**CITY OF SAINT PAUL
HERITAGE PRESERVATION COMMISSION STAFF REPORT**

FILE NAME: 1034 Summit Avenue
DATE OF APPLICATION: November 4, 2015
APPLICANT: Barbara D'Aquila
OWNER: Barbara D'Aquila
DATE OF HEARING: December 17, 2015
HPC SITE/DISTRICT: Historic Hill Heritage Preservation District
CATEGORY: Pivotal
CLASSIFICATION: Right-of-Way
STAFF INVESTIGATION AND REPORT: Amy Spong
DATE: December 9, 2015

B. PROPOSED CHANGES:

File # 15-139325

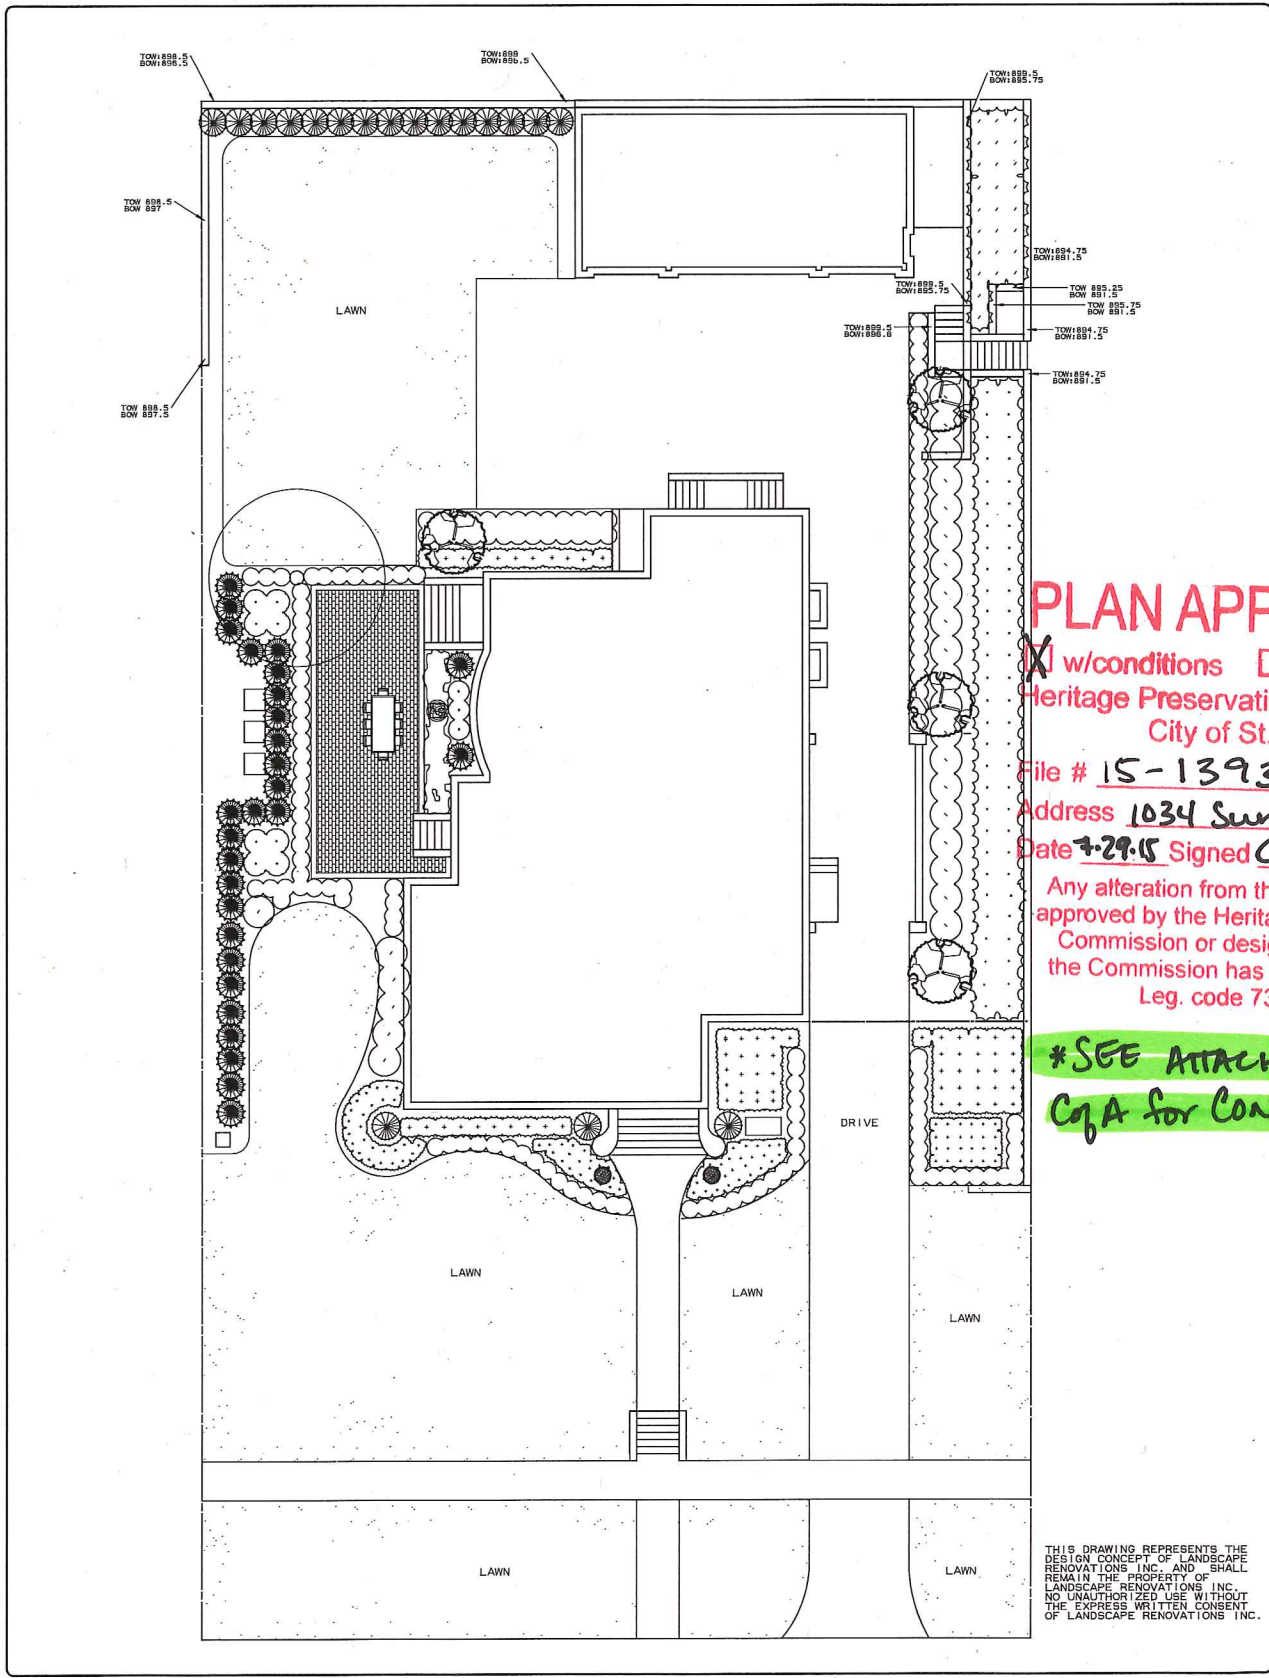
- 1) The new concrete driveway shall replicate the historic carriage lines present in the existing concrete driveway. These carriage lines shall be present from Summit Avenue to the driveway porte-cochère.
- 2) The size of the walkway shall not be altered.
- 3) The rise and run of the front lawn steps shall be in the same proportions as the existing steps.
- 4) The new terrace steps shall be no wider than the existing steps.
- 5) If a new railing is installed, it will require additional review by HPC Staff.

Attachment 5
 THIS [DESIGN [RENOVATION [REMAIN [LANDSCAPE [NO UNACCEPTABLE [THE EXISTING [OF LAND

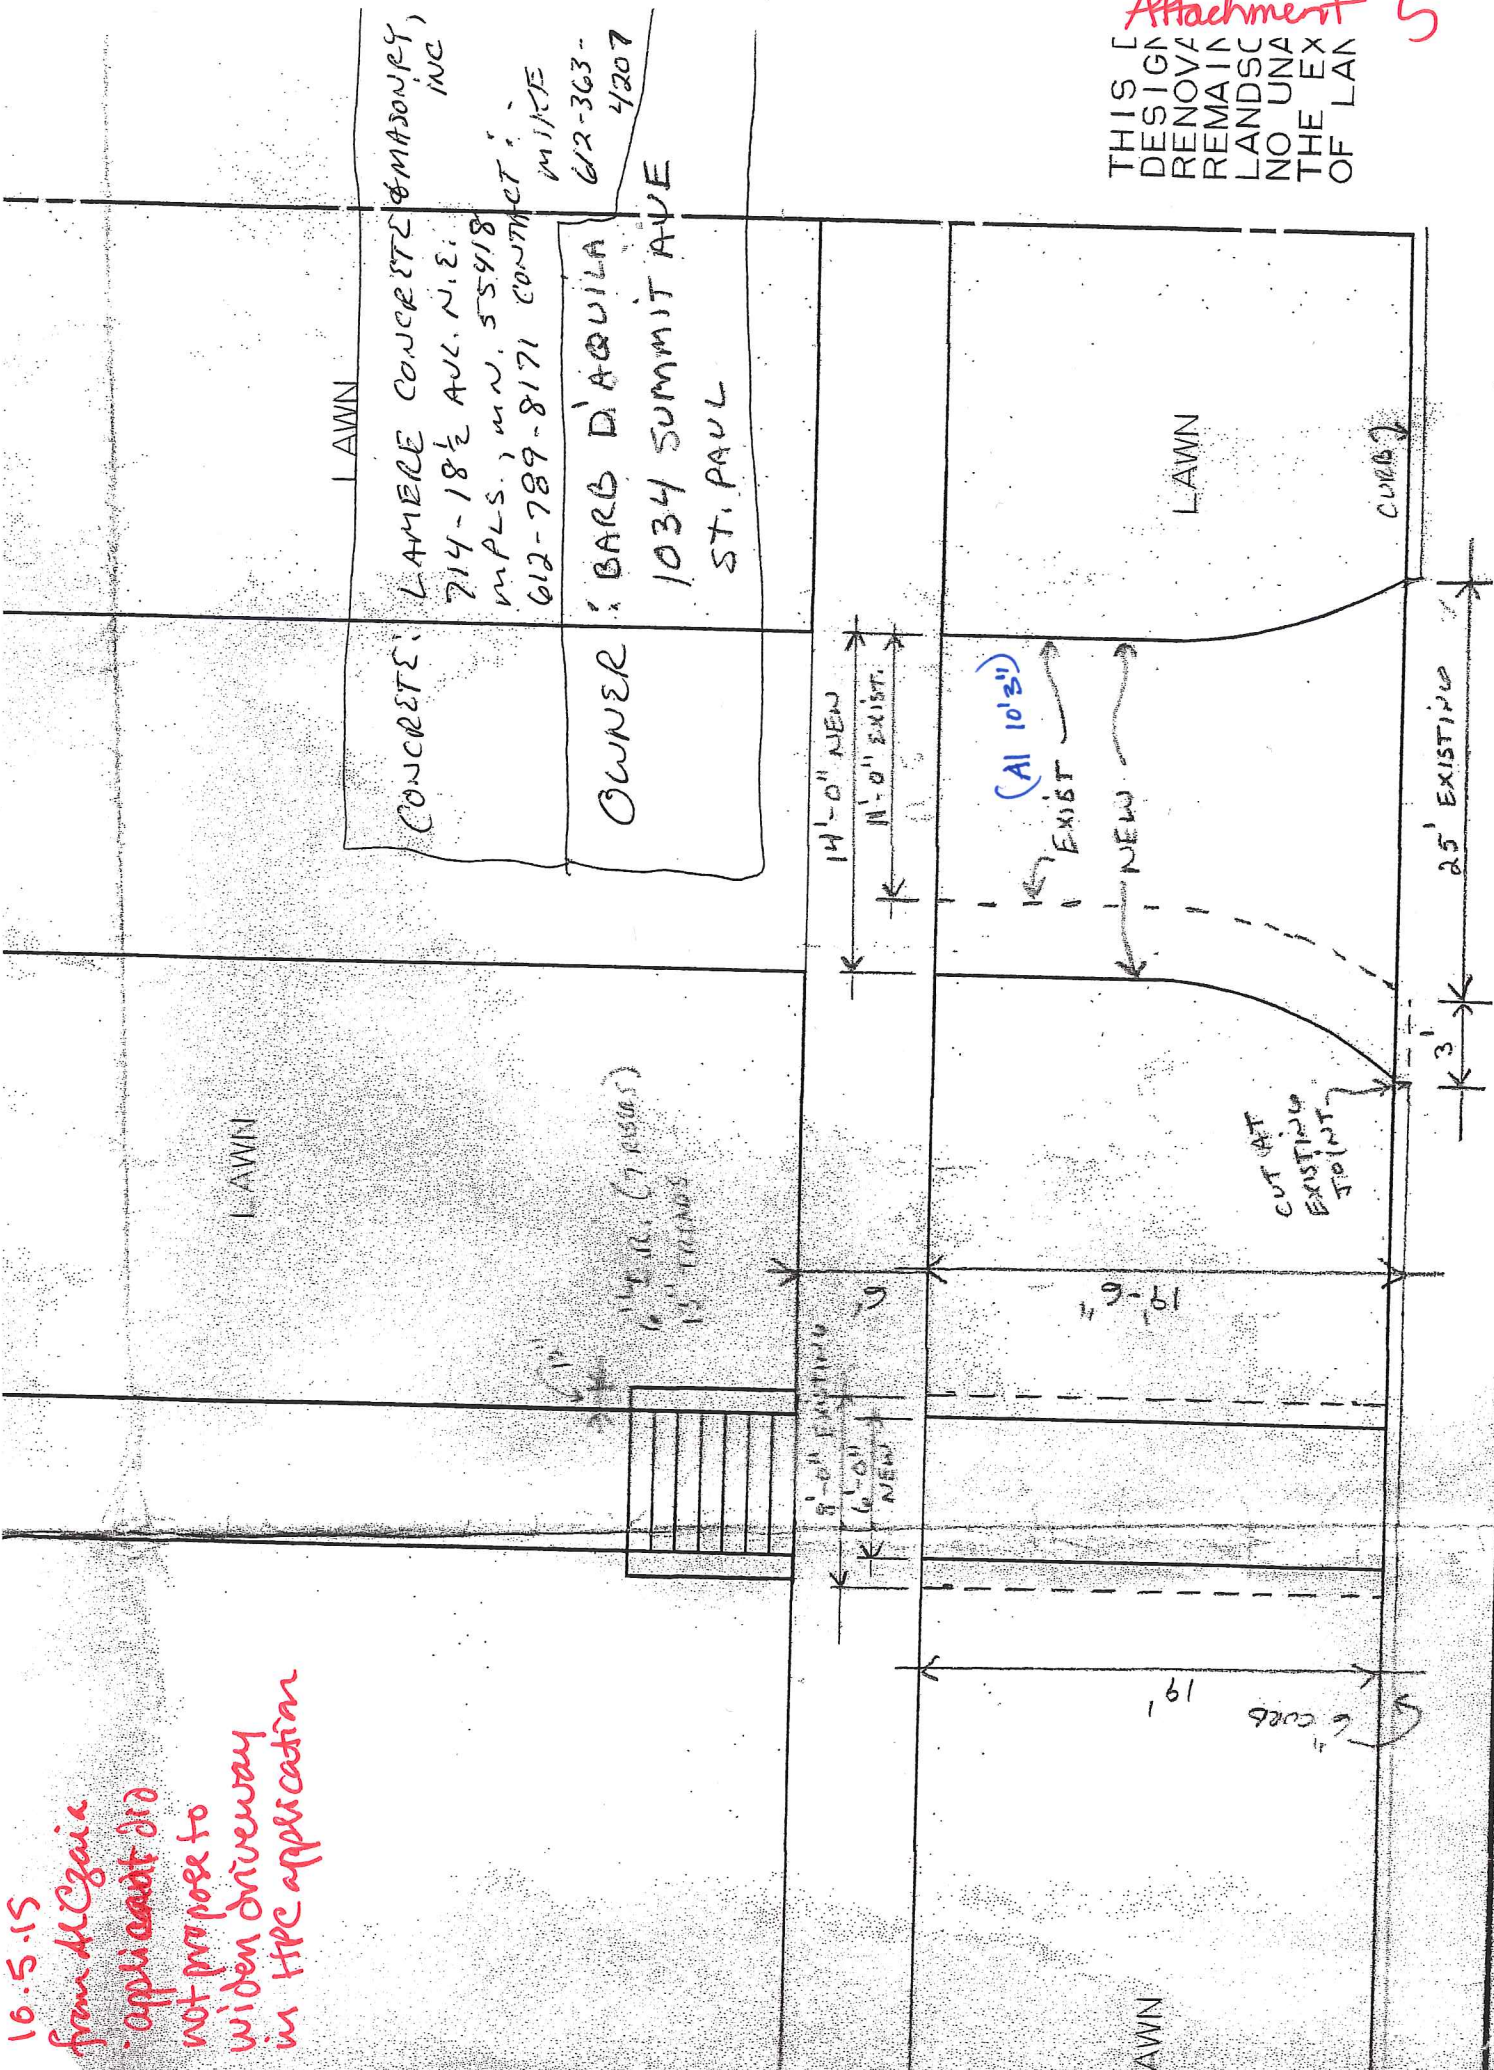
16.5.15
 from McQuinn
 - applicant did
 not propose to
 widen driveway
 in the application
